CITY OF MADISON

PLAN OF PROPOSED IMPROVEMENT

3030 OHMEDA DRIVE CSM (SIDEWALK PLAN ALONG FEMRITE DRIVE)

CITY PROJECT NO. 13825
CONTRACT NO. ~~9802~~ 9082

FEMRITE SIDEWALK REVISIONS

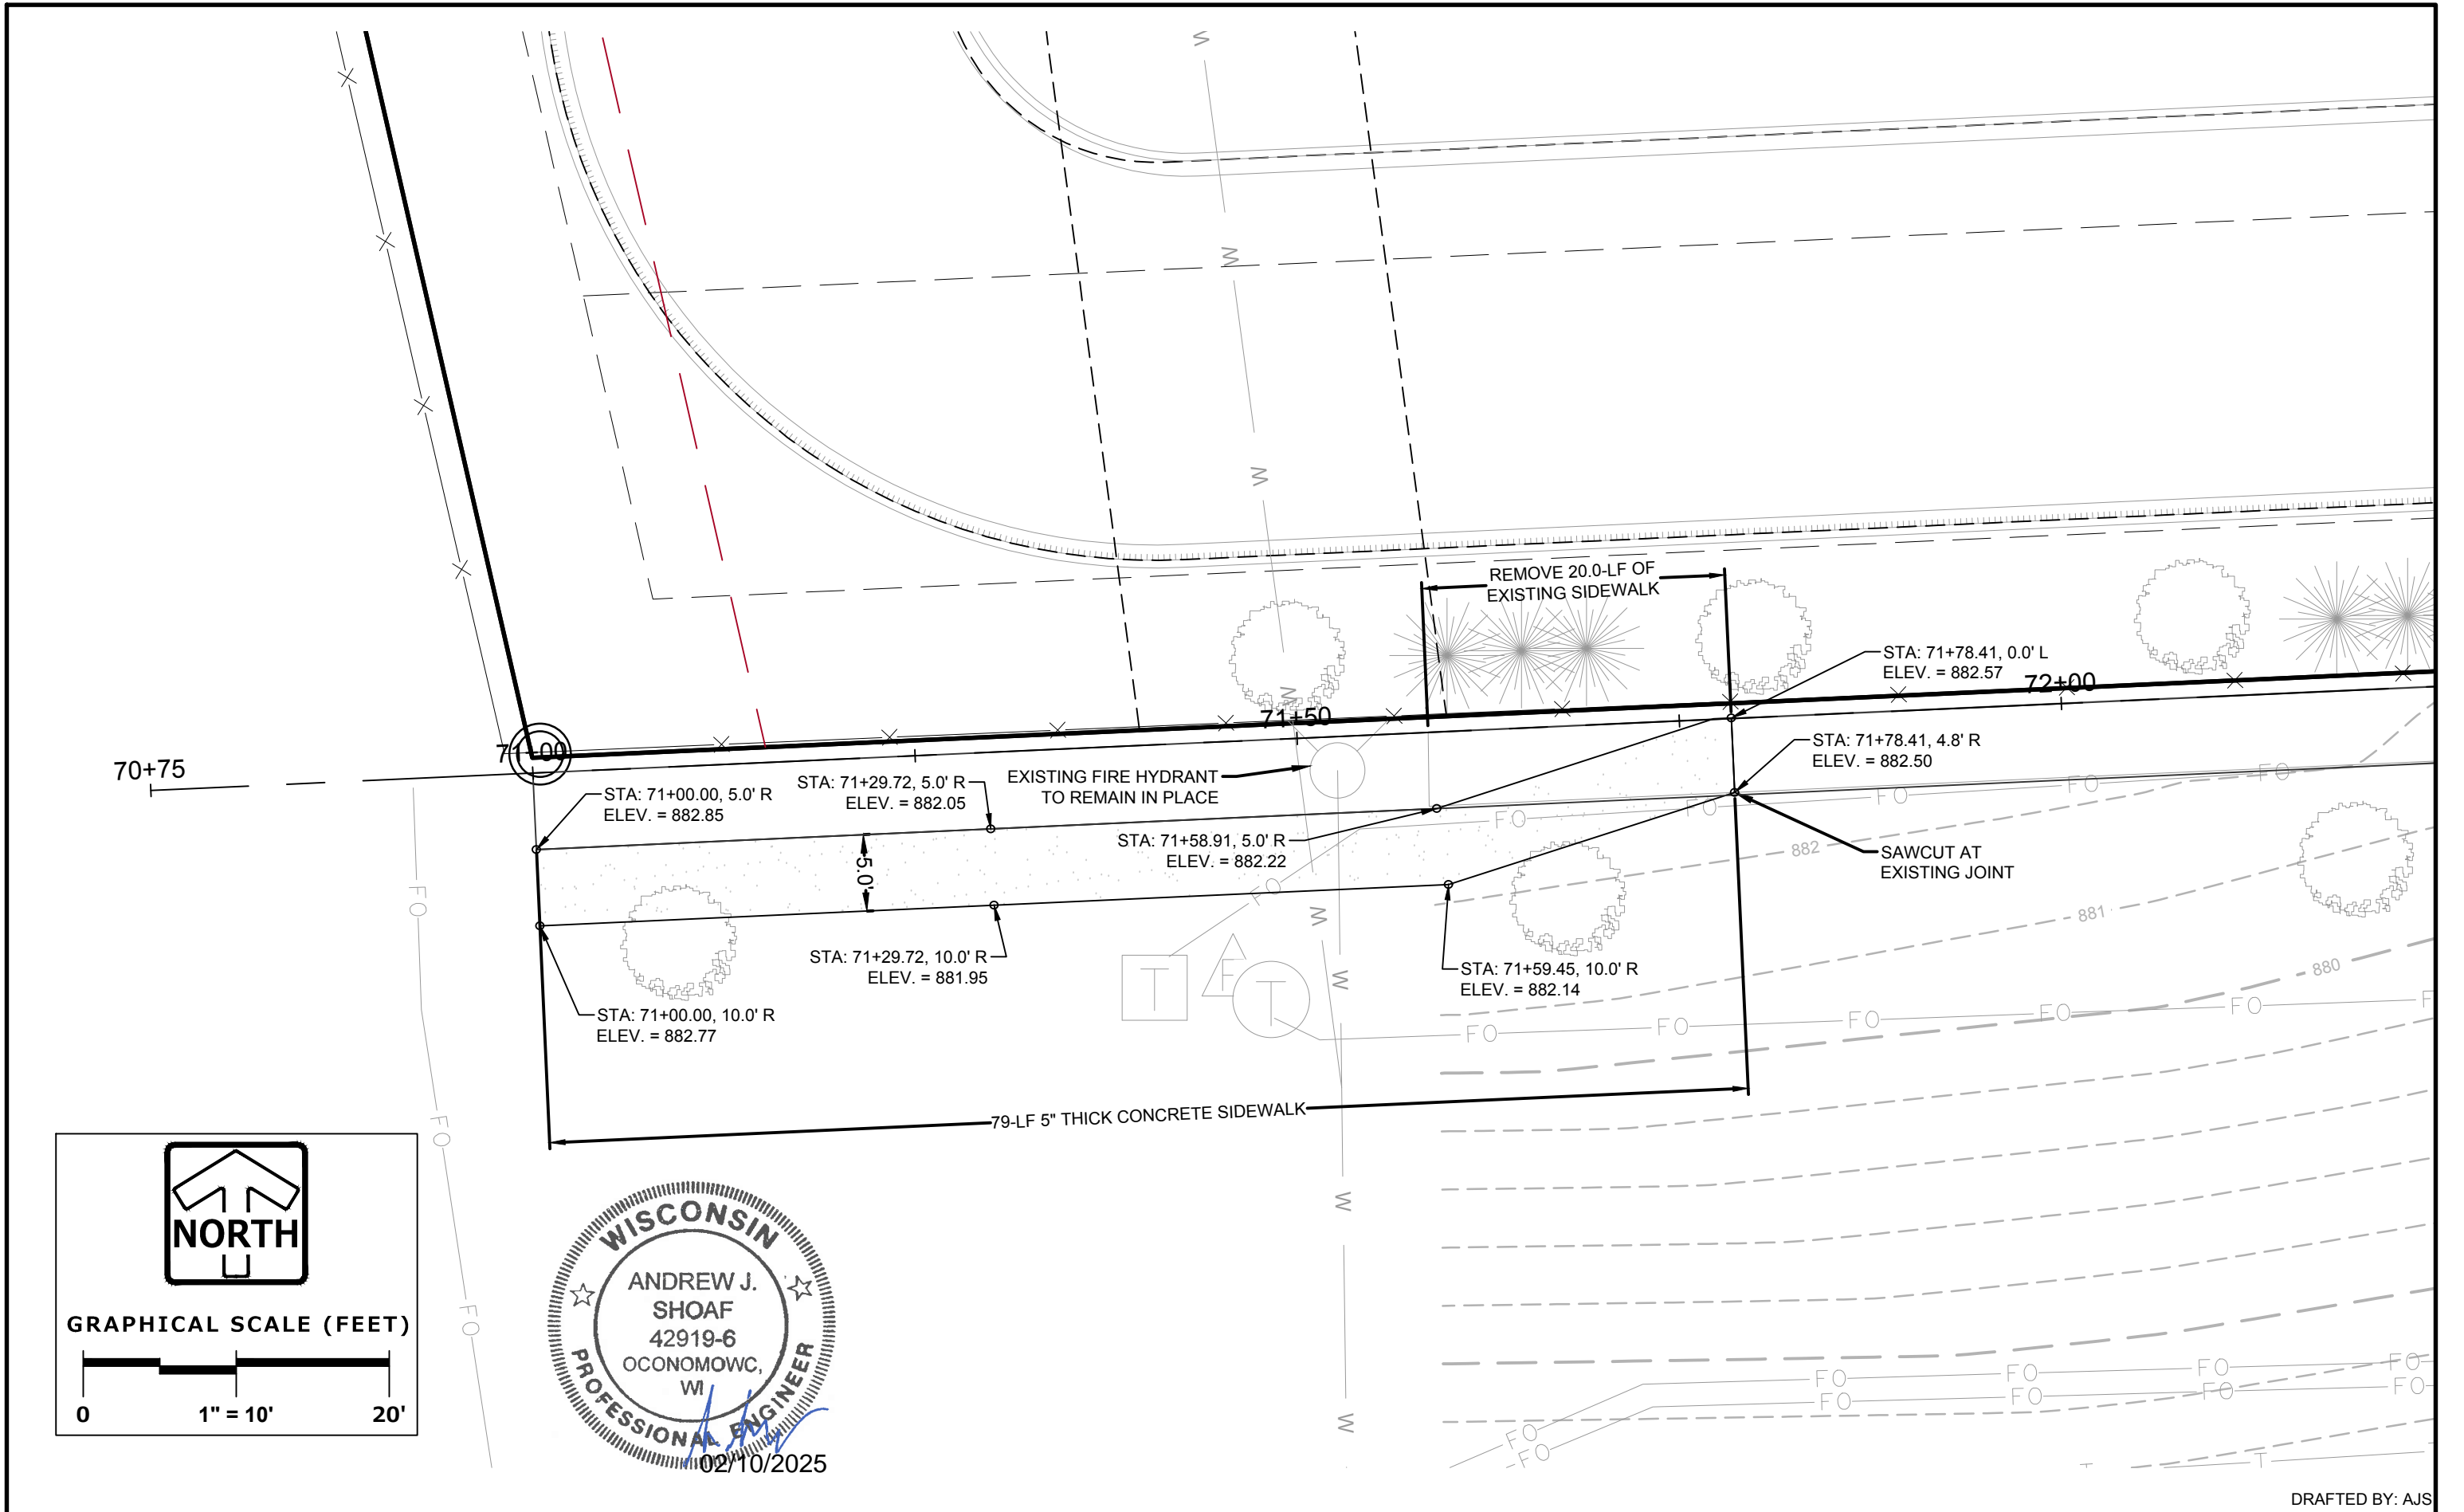
- PLAN REV #1 1-5-2024
- ADDED WATER MAIN SHEET
- PLAN REV #2 2-19-2025
- RELOCATE SIDEWALK ALONG THE WEST OF THE PROPERTY AROUND THE FIRE HYDRANT
- REVISE THE DITCH & DRIVEWAY CULVERT FOR THE EASTERN MOST DRIVEWAY

FEMRITE DR - WATER PLAN & PROFILE
 3030 OHMEDA DRIVE CSM
 M:\DESIGN\Projects\13825\CAD\Water\13825 - Water - Femrite Dr CSM.dwg

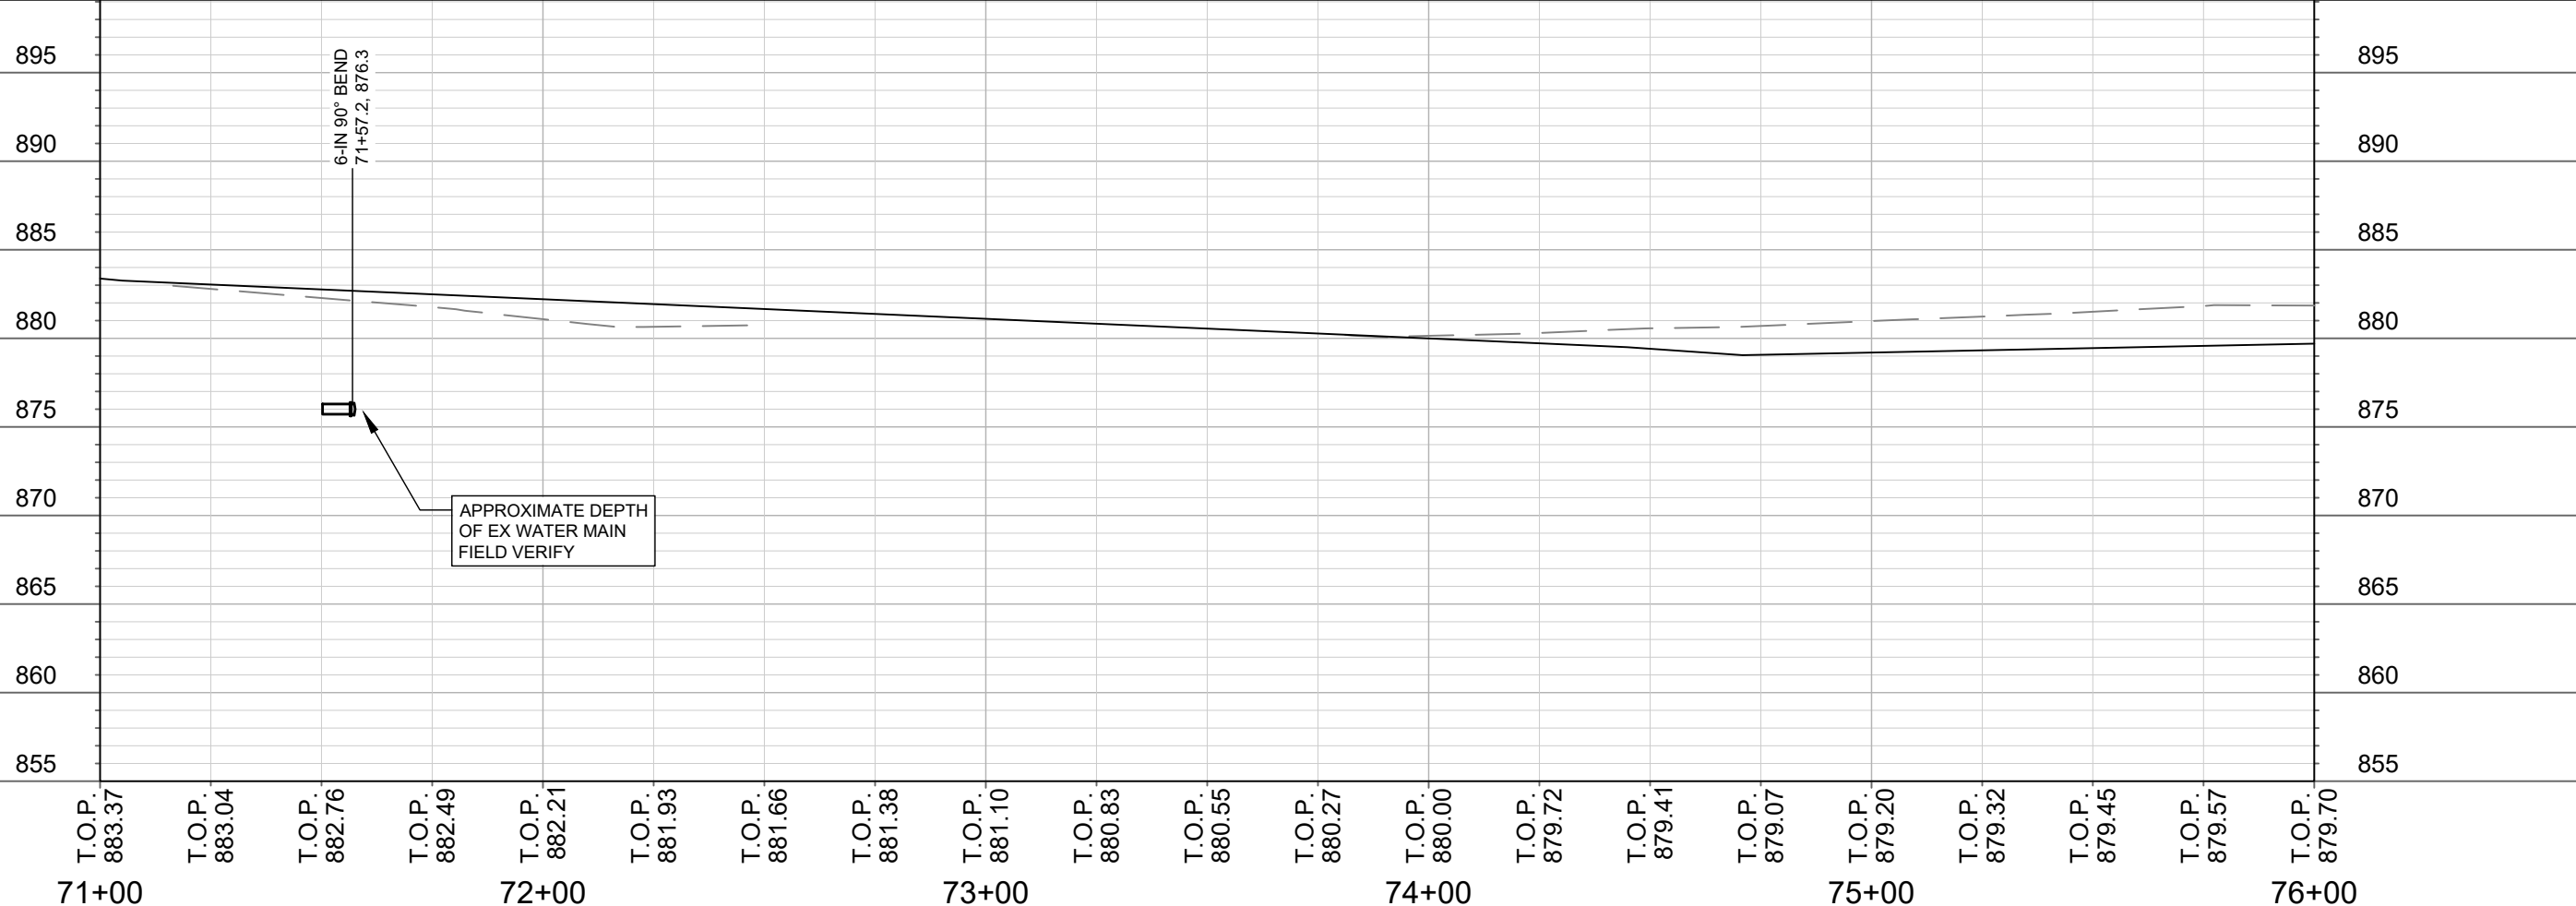
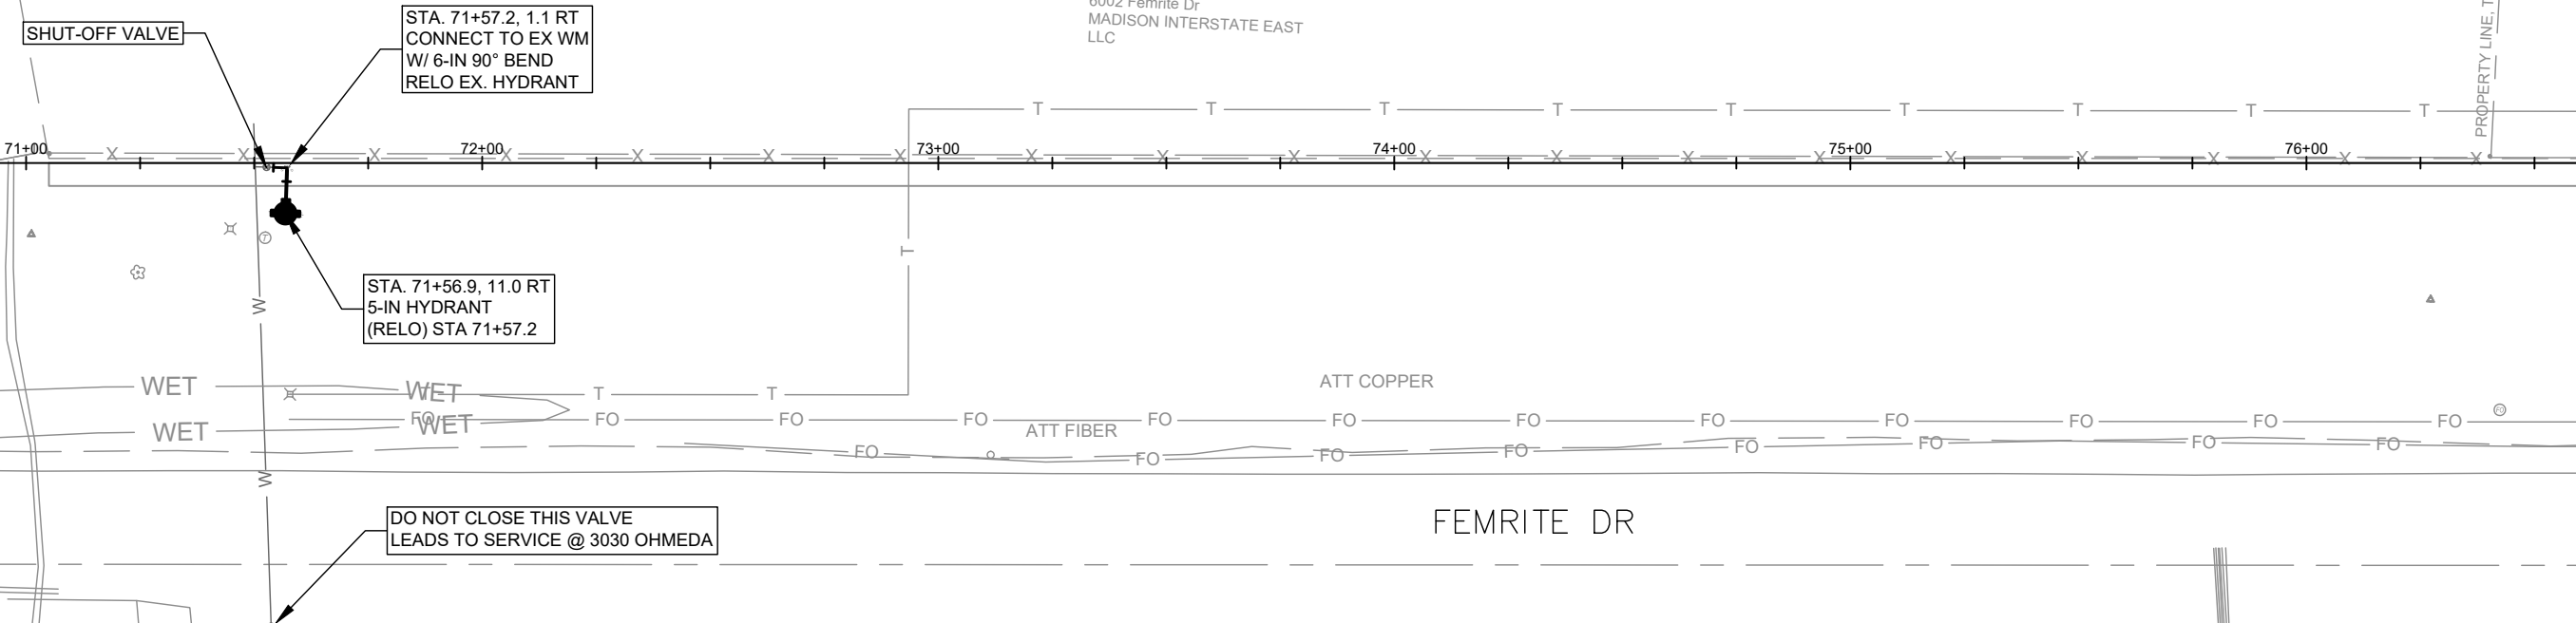
Revision 1 - RJN 1/5/24
 - Relocate hydrant due to sidewalk conflict
 - Must complete modify mains application before water work starts.
